SITE PLAN APPROVAL - Lexington Place

PROJECT INFORMATION								
Project Title	Lexington Place		Date of Report	March 10, 2020				
File Number	PA 18036		Attachments	Preliminary Site Plan (Exhibit 37)				
Administrative Recommendation	Approve the preliminary Multi-family Site Plan subject to the conditions of approval contained in Section 2.0 of this Administrative Site Plan Approval.							
BACKGROUND SUMMARY								
Applicant	Grandview North, LLC							
Request	The applicant is requesting Administrative Multi-family Site Plan Approval in order to construct an 18-unit, 3-story apartment complex, and associated parking, open space, landscaping and stormwater improvements.							
SEPA Status	Exempt pursuant to MMC 22E.030.090(1)(b)							
Site Location	Northwest corner of 51 st Ave. NE and 100 th St. NE		APN(s)	30051600108800				
Acreage (SF)	0.72 acres (31,363 SF)		Section	16	Township	30	Range	05
Comprehensive Plan	MFM	Zoning	R-18	Shoreline Environment		N/A

EXHIBIT 37
Approved Site Plan
03.10.20

GRANDVIEW HOMES LLC
LEXINGTON PLACE
PA18036
SITE PLAN
CITY OF MARYSVILLE, WA

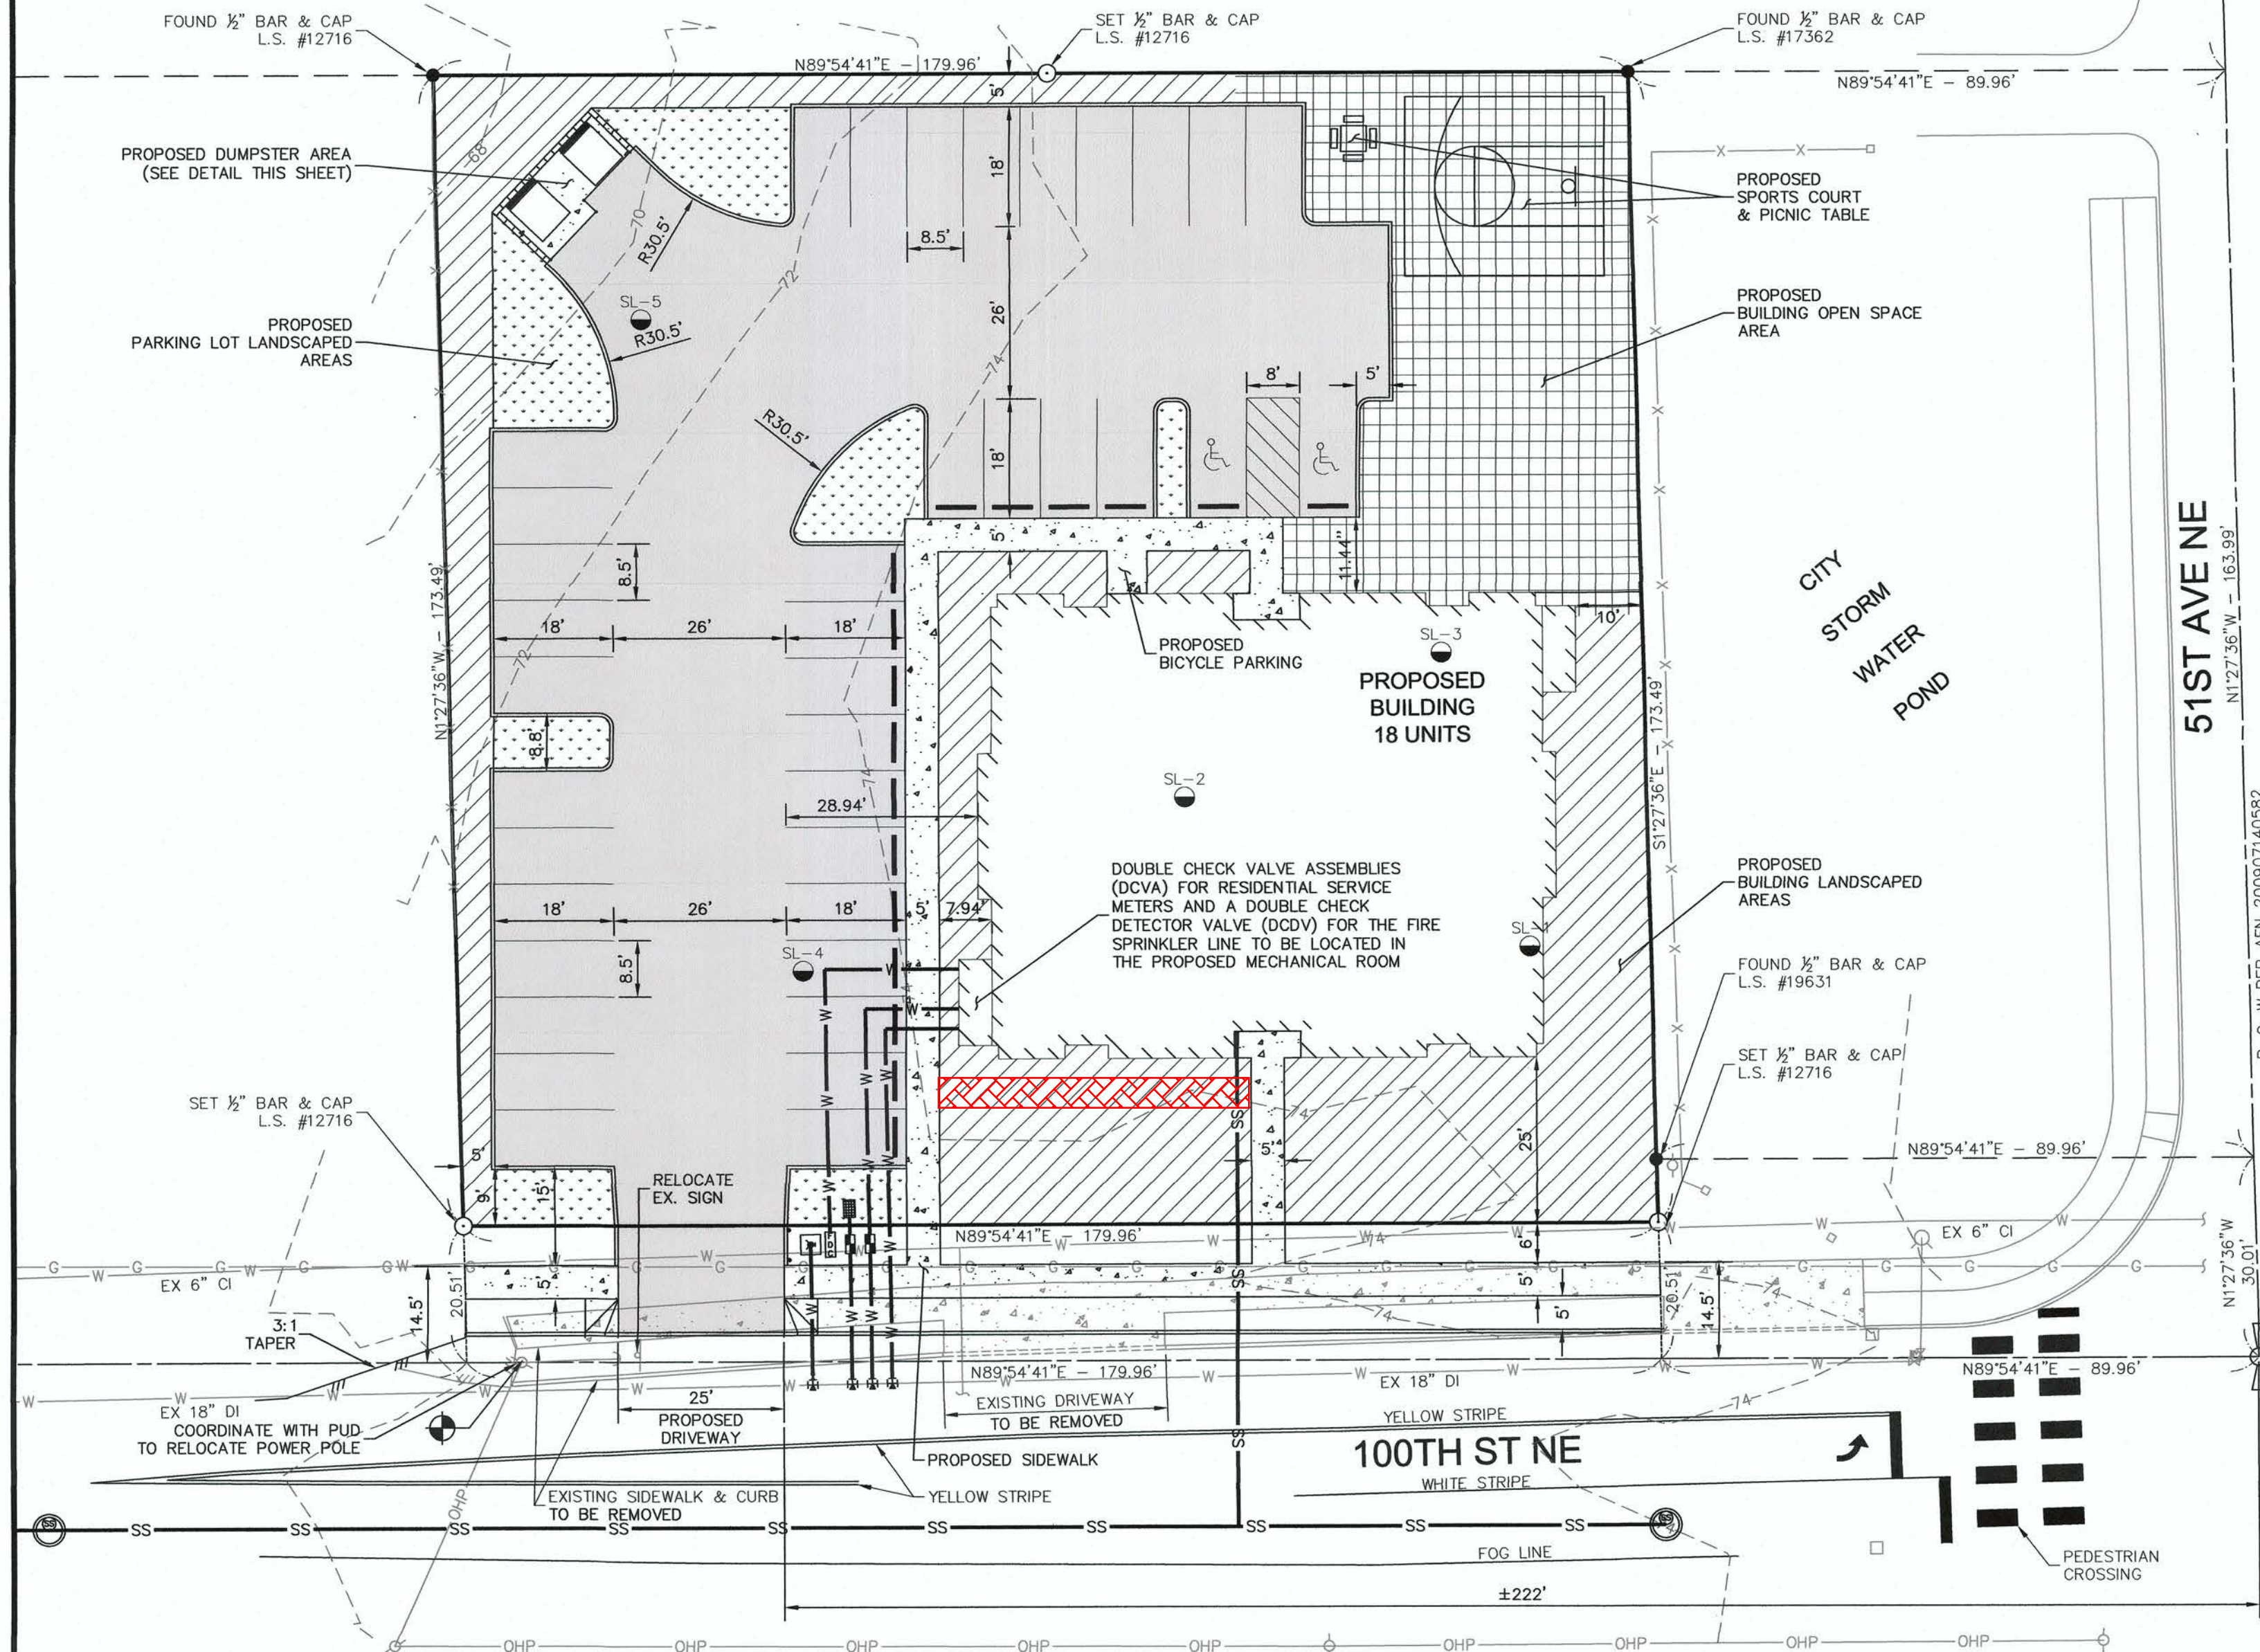
1. The preliminary site plan received by the Community Development Department on January 9, 2020 (Exhibit 37) shall be the approved preliminary site plan layout subject to the following amendment:

- . A minimum 5 foot wide pedestrian pathway shall be provided from the south entry, west to the parking lot. This is in addition to the proposed pedestrian pathway provided from the south entry to the public sidewalk located on 100th Street NE. The improvement shall be required to be shown on the final civil construction and landscape plans.
